**ADDENDUM
PLAN COMMISSION STAFF REPORT
PC 25-021**

Agenda Item: PC 25-021: SUBDIVISION , The Pavilion on 45th

Subject: Addendum to January 13, 2026 Plan Commission Staff Report

Lake County Surveyor's Office Web Map

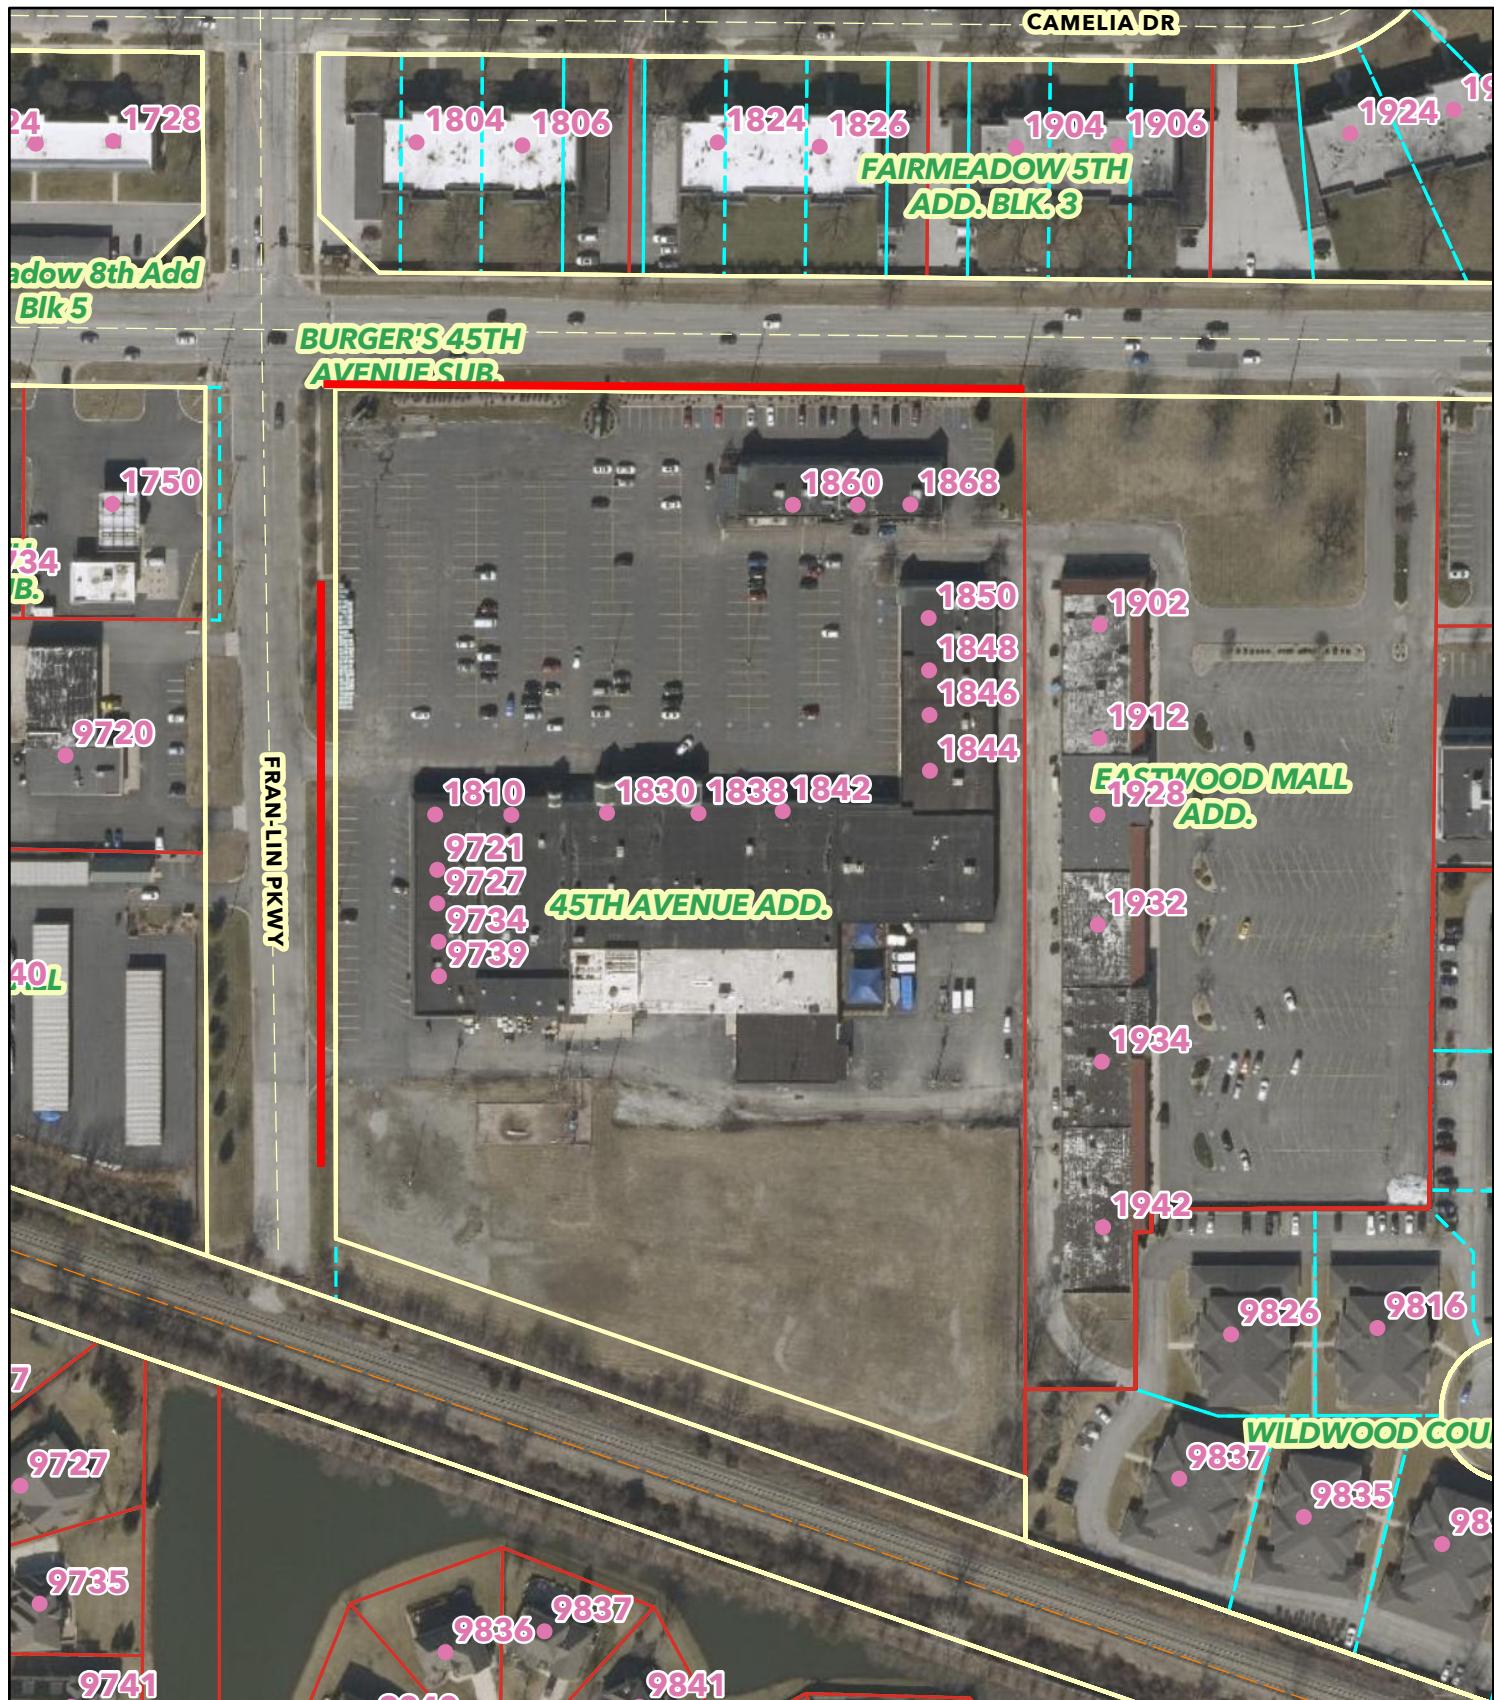
The first engineering recommendation is a cost estimate for public improvements of \$65,000. The Town engineers have identified the installation of missing and required sidewalk along the Fran-Lin Parkway and 45th Avenue frontages of the development. An attached aerial image identifies the two location of missing sidewalks. The engineer notes that the adjacent sidewalks along 45th were approximately 5-feet wide and the public improvement estimate is calculated on this dimension and includes:

1. 5' wide sidewalk (5" concrete over 4" aggregate)
2. Curb ramps with ADA detectable warning fields
3. Curb and gutter removal and replacement at driveways
4. Limited turf restoration
